TITLE:-3LEAF RIGHT SIDE
CRM-04

CLIENT - LESTECH
LOCATION - POSCO MANGAON
PRODUCT - SLIDING DOOR
DWG NO:-NIHVA/22-23/CLT/0018 | REV- 0
SCALE: NTS | SCALE:-- 1:1 | SHEET: 01 OF 01

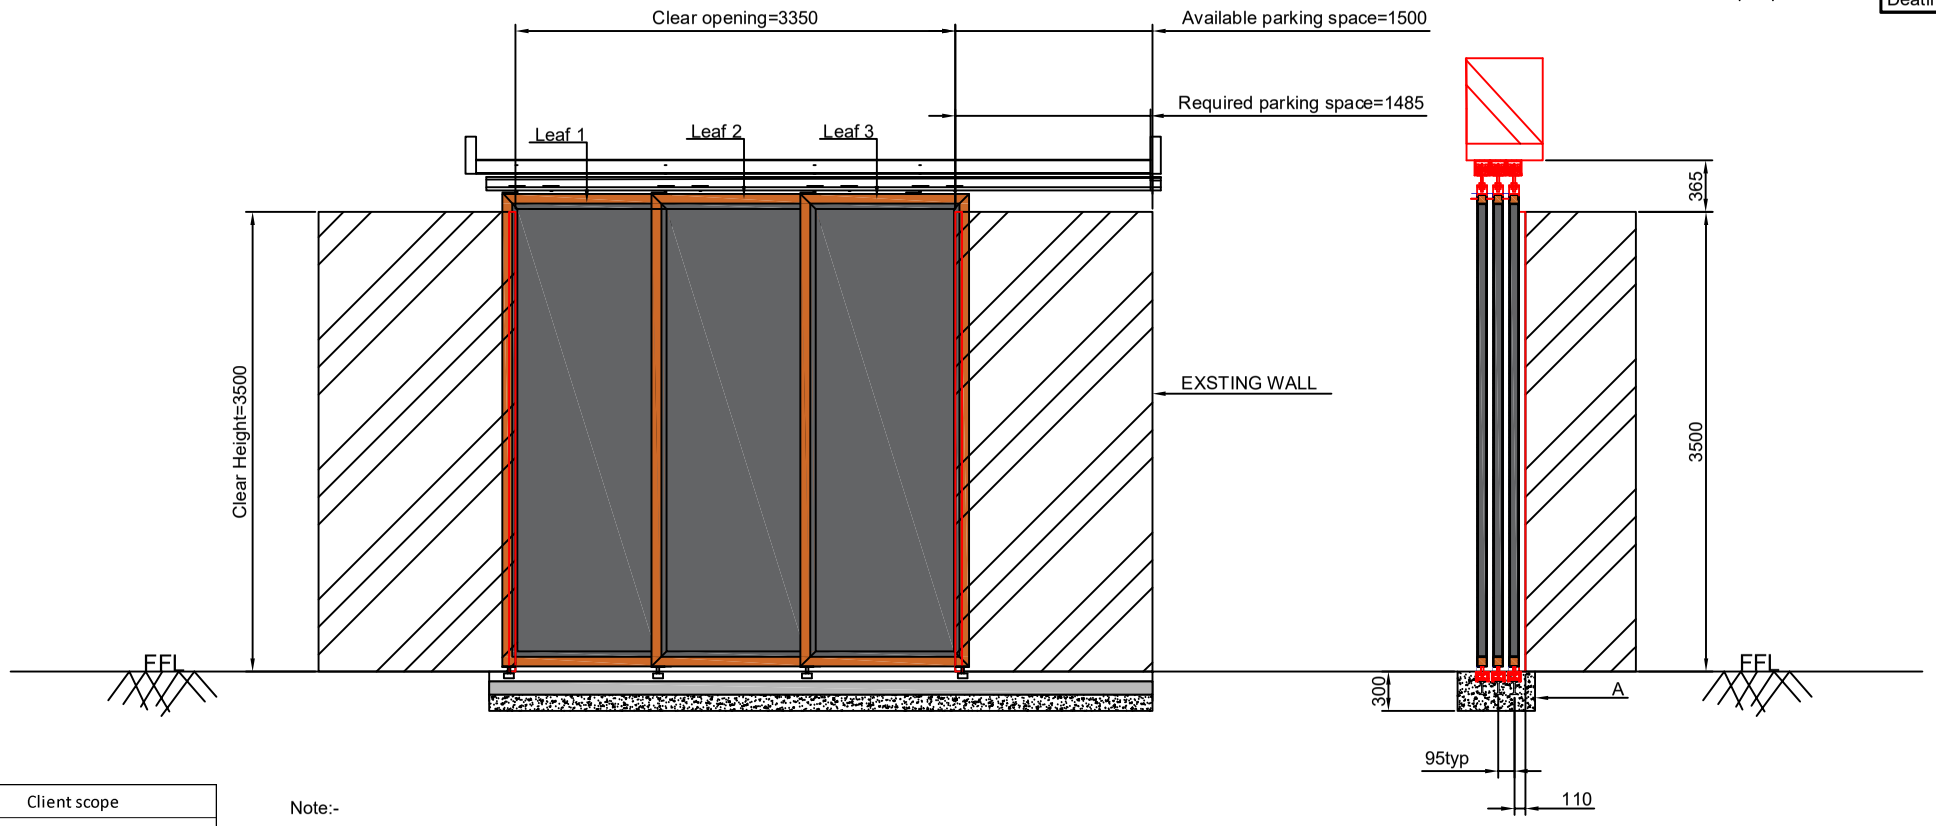
Client scope
*Roof need to be shift at top Approx 300mm *Drainage area need to be remove frome left side appox.200mm *Gutter area need to be remove *Civil foundation need to be done for tracks
